REVISED JULY 22, 2024
(CORRECTED)

**RE: MASSDEP File #090-1428, Haggetts Pond Rail Trail Project
0,051R & 52 Haggetts Pond Road, Andover, MA**

The following response addresses the comments received from LEC Environmental in the Initial Peer Review dated January 9, 2024 from Ann Marton.

Figure 1

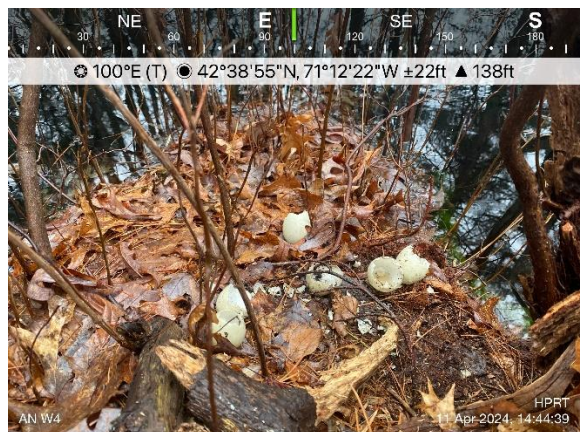
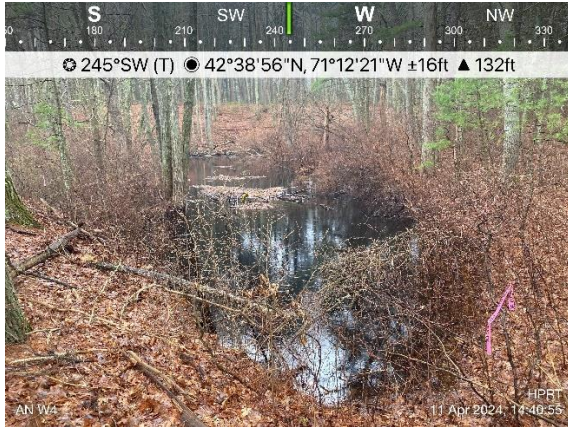
- 11) **Two depressions along the trail delineated by flags W3-100 through W3-110 and W9-101 through W9-108 exhibit distinct vernal pool characteristics. BSC Group should opine in writing on the likelihood that these areas provide vernal pool habitat and function as vernal pools. Add to the plans the appropriate vernal pool setbacks. LEC recommends that BSC Group evaluate measures to increase habitat diversity and wetland protection in the vicinity of these pools. You must provide mitigation to offset impacts within the VP setbacks to demonstrate compliance with the Bylaw Regulations and/or to receive a Waiver for this work.**

Previously, two wetlands, W3 and W9 were discussed as exhibiting vernal pool characteristics. There are no Potential Vernal Pools in the vicinity of the project, but the heavy conifer cover in the Haggetts Pond area may have contributed to their absence from the Potential Vernal Pool data, and there is no certified vernal pool as of the date of this response letter. Conservation staff have shared observations of vernal pool indicator species provided by a local resident in various locations throughout the Site. BSC therefore conducted a field investigation of all waterbodies that appear to have potential to provide vernal pool function on April 11, 2024 in an attempt to verify observations to the extent possible.

Wetland W9 from railbed at culvert crossing looking North. Stream feeds ponded area and continues eastward through a culvert at photo center.

Amphipods and fingernail clams found in W9. No amphibian evidence was found.

Wetland W3 from railbed. No amphibian egg masses found. Very full of algae throughout pool.

Depredated duck nest found in W3.

Wetland W4 from railbed.

Many wood frogs egg masses found in W4.

Based upon our field evaluations on April 11, 2024, we have detected vernal pool obligate wildlife in Wetland 4 but were unable to find egg masses or other indicators of vernal pool organisms in Wetland 3 or Wetland 9. Conditions were not ideal for the survey, so based upon general characteristics of Wetlands 3 and 9, BSC assumes that they are most likely functional vernal pools, at least in some years, and therefore has not made any change to the assumption that they are vernal pools. Wetland 4 has been added as a vernal pool in project plans and associated calculations.

Figure 2

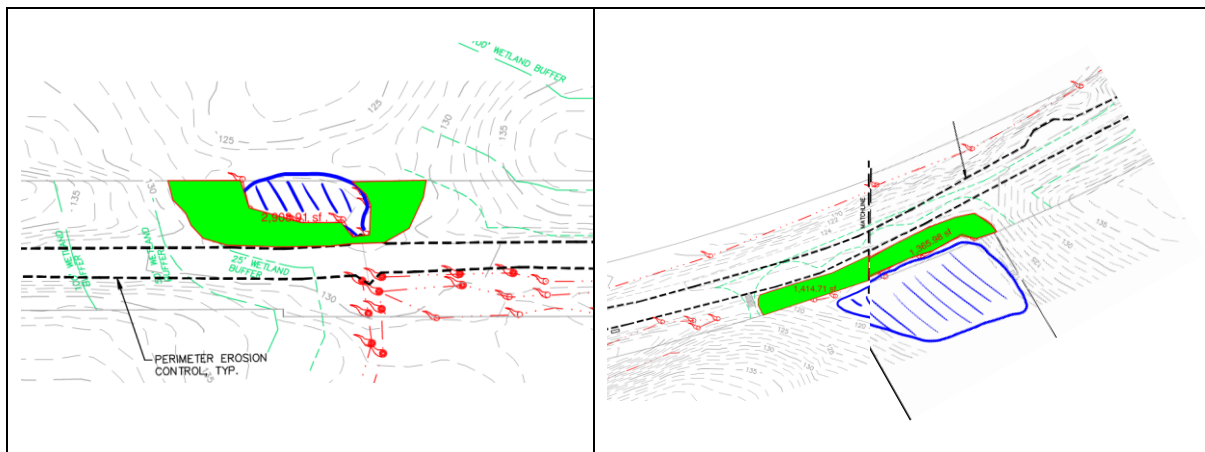
- The Project does not comply with the minimum setback for Building/Structures in the Andover Wetland Protection Regulations at Section 4(3) and will therefore require a waiver of this bylaw requirement. To mitigate unavoidable work within the 75-foot vernal pool building/structure setback, BSC is recommending improvements to the habitat around the vernal pool at Wetland W9 to enhance the vegetative buffer especially on the west side of the wetland, which is presently in a sparsely vegetated condition with little mid-story (shrub/sapling) vegetation. A dense planting of Sweet Pepperbush (*Clethra alnifolia*) comprising approximately 2,040 SF at wetland W9 and additional Sweet Pepperbush plantings within approximately 1,730 SF of the Buffer Zone screening wetland W3 would provide a physical and visual barrier to discourage off-leash dog access to the presumptive vernal pool, and improve shelter, non-breeding habitat, migratory, and feeding habitat functions of this wetland. We note that existing *Clethra* populations at W4 are very dense and don't believe that additional plantings would be feasible or beneficial at this location. Please see sheet L-100 for the buffer plantings.

W9 habitat enhancement planting area

W3 habitat enhancement planting area

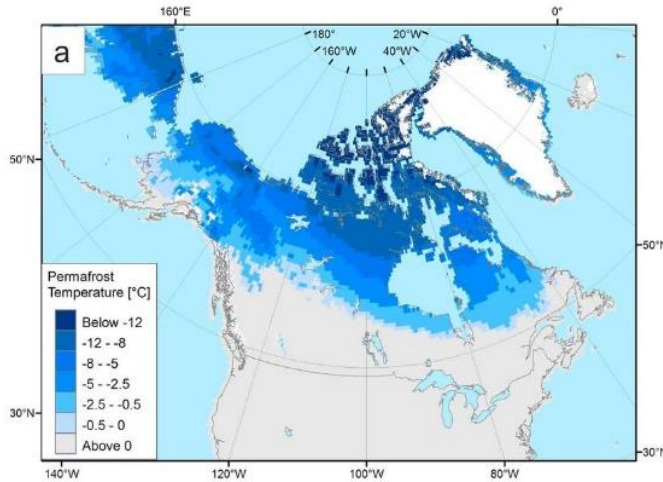
According to the National Snow and Ice Data Center (a part of CIRES at the University of Colorado Boulder), "Permafrost is soil, sand, sediment, or rock **that remains at or below 0 °C (32 °F) for at least two years...** In total, permafrost occupies approximately 23 million square kilometers (9 million square miles) or about 25 percent of the exposed land surface in the Northern Hemisphere, with approximately 65 percent in Eurasia and the other 35 percent in North America and Greenland. However, most permafrost in the Northern Hemisphere occurs poleward of 60°N in Russia, Canada, and northern Alaska."

Haggetts Pond is located at 42°00' N in a zone that experiences seasonally frozen ground that reaches depths between 36" and 72" for up to several weeks in most winters but is approximately 700 miles south of the nearest areas of permafrost in North America, which reach no lower than approximately 50°N in eastern Quebec and the northern maritime provinces (Figure 9).

Figure 9 This project will have no effect on permafrost or global methane emissions from its thawing, and nonetheless does not propose to disturb wetland soils in any way. The project will therefore have no effect of releasing carbon stored in permafrost as methane gas as posited by the commenter at the January public hearing.
